Contract #: 04-0120F4
 Cty: SF/ALA Rte: 80 PM: 13.2/13.9
 File #: 69.25B

QUALITY ASSURANCE -- NON-CONFORMANCE REPORT

Report No: NCR-000745

Reference Description: Gap Between Mill-to-Bear Surfaces, West Shaft, Lift 1

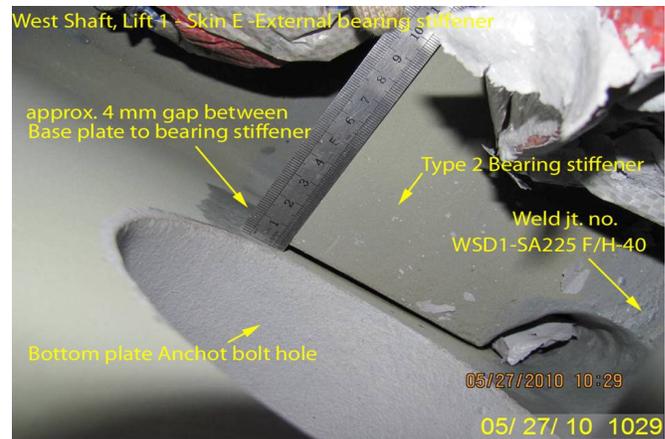
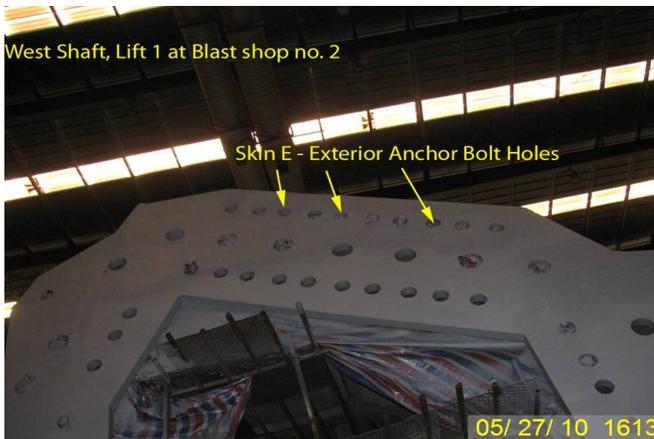
During the Quality Assurance (QA) Inspection of Anchor Bolt to Bearing stiffener distance measurement at West shaft Skin E, external side, Caltrans QA discovered the following issue:

- Approx. 4 mm gap found between Type 2 Bearing stiffener and Base plate.
- This Type 2 bearing stiffener weld joint with Type 1 stiffener is identified as WSD1-SA225F/H-40

Drawing no.- 180R2 – Tower Anchorage Details no. 5

Note no. 10 –Bearing stiffener PL#2 shall be milled to bear against tower Base plate

AWS D1.5 Section: 3.5.1.9: “The bearing ends of bearing stiffeners shall be flush and square with the web and shall have at least 75 percent of this area in contact with the flanges. When bearing against a steel base or seat,

all steel components shall fit within 1 mm [1/32 in.] for 75 percent of the projected area of the web and stiffeners”

ZPMC has corrected this issue using shims. This gap has been inspected by the Department and found to be acceptable. ZPMC is providing the notifications numbers and dates so that this acceptance by the Department's inspectors can be verified. Based on this ZPMC requests closure of this NCR.

This proposed resolution is accepted with action pending. The Department has inspected the gap referenced in this NCR and has found the repair to be acceptable; however, due to any unforeseen movement during shipping or handling the Department will final inspect the members after they are installed in Oakland. Once this inspection takes place, this NCR will be considered closed.

Reference Description: Gap Between Mill-to-Bear Surfaces, West Shaft, Lift 1

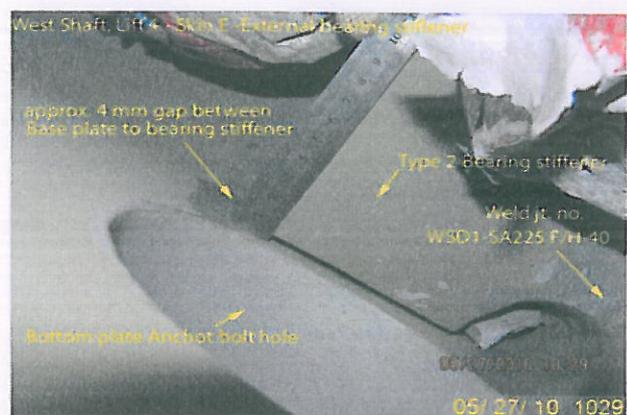
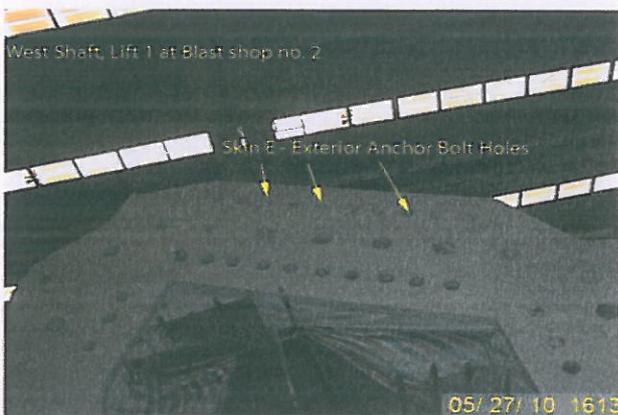
During the Quality Assurance (QA) Inspection of Anchor Bolt to Bearing stiffener distance measurement at West shaft Skin E, external side, Caltrans QA discovered the following issue:

- Approx. 4 mm gap found between Type 2 Bearing stiffener and Base plate.
- This Type 2 bearing stiffener weld joint with Type 1 stiffener is identified as WSD1-SA225F/H-40

Drawing no.- 180R2 – Tower Anchorage Details no. 5

Note no. 10 –Bearing stiffener PL#2 shall be milled to bear against tower Base plate

AWS D1.5 Section: 3.5.1.9: “The bearing ends of bearing stiffeners shall be flush and square with the web and shall have at least 75 percent of this area in contact with the flanges. When bearing against a steel base or seat,

all steel components shall fit within 1 mm [1/32 in.] for 75 percent of the projected area of the web and stiffeners”

Contractor proposes to install shim plates to fill the gaps, sealed by caulking. The retrofit will be re-inspected after the arrival in the United States.

Contractor installed the shim plates, and caulked the gaps and the retrofit works accepted by QA prior to shipment. Re-inspection on arrival in the States for all four Tower Shafts took place and found satisfactory.
